State of New Mexico
Energy, Minerals and Natural Resources

SUNDRY NOTICES AND REPORTS ON WELLS
(DO NOT USE THIS FORM FOR PROPOSALS TO DRILL OR TO DEEPEN OR PLUG BACK TO A DIFFERENT RESERVOIR. USE "APPLICATION FOR PERMIT" (FORM C-101) FOR SUCH PROPOSALS.)

Plug and Abandonment Procedure**Orphan Well Program****Chaveroo San Andres Unit #5****API #30-041-20309****Unit K, 1980' FSL and 1980' FWL Sec. 35, T7S, R32E****Roosevelt County, NM**

State of New Mexico		PROPOSED	
Author:	Abby @ JMR	Well No.	#5
Well Name	Chaveroo SA Unit	API #:	30-041-20309
Field/Pool	Chaveroo; SA	Location:	K-35-07S-32E
County	Roosevelt		1980 FSL & 1980 FWL
State	NM	GL:	
Spud Date	1/29/1970

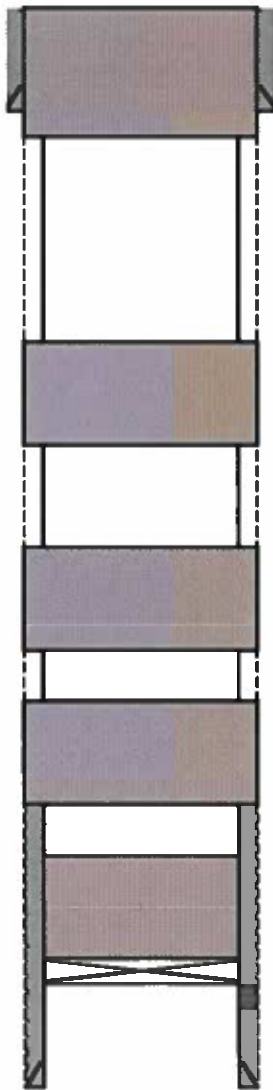
5
76
Plug #5: Surface casing Shoe: Squeeze 70' sx Class C cement plug from 405' to 5' and circulate good cement out casing and annulus.
8 5/8 24# CSG @ 355
Hole Size: 12 1/2

$4\frac{1}{2} \times 7\frac{7}{8} = 9\text{ sx}$
 $4\frac{1}{2} \times 8\frac{7}{8} = 67\text{ sx}$

49
1620'
Plug #4: Perf & Sqz 30' sxs Class C cement inside/outside from 1770' to 1800'. WOC & Tag.
outside 35 sx
inside 14 sx

67
2150'
Plug #3: Perf & Sqz 58' sxs Class C cement inside/outside from 2310' to 2800'. WOC & Tag.
outside 56 sx
inside 11 sx

262
2850'
Plug #2: Perf & Sqz 110' sx class C cmt inside/outside from 3480' to 2800'. WOC & Tag.
outside 218 sx
inside 44 sx

21
Plug 1: Set CIBP @ 4103' mix and pump 28' sxs Class C cement from 4103' to 3800'. WOC & Tag.
Perfs @ 4153-4353'
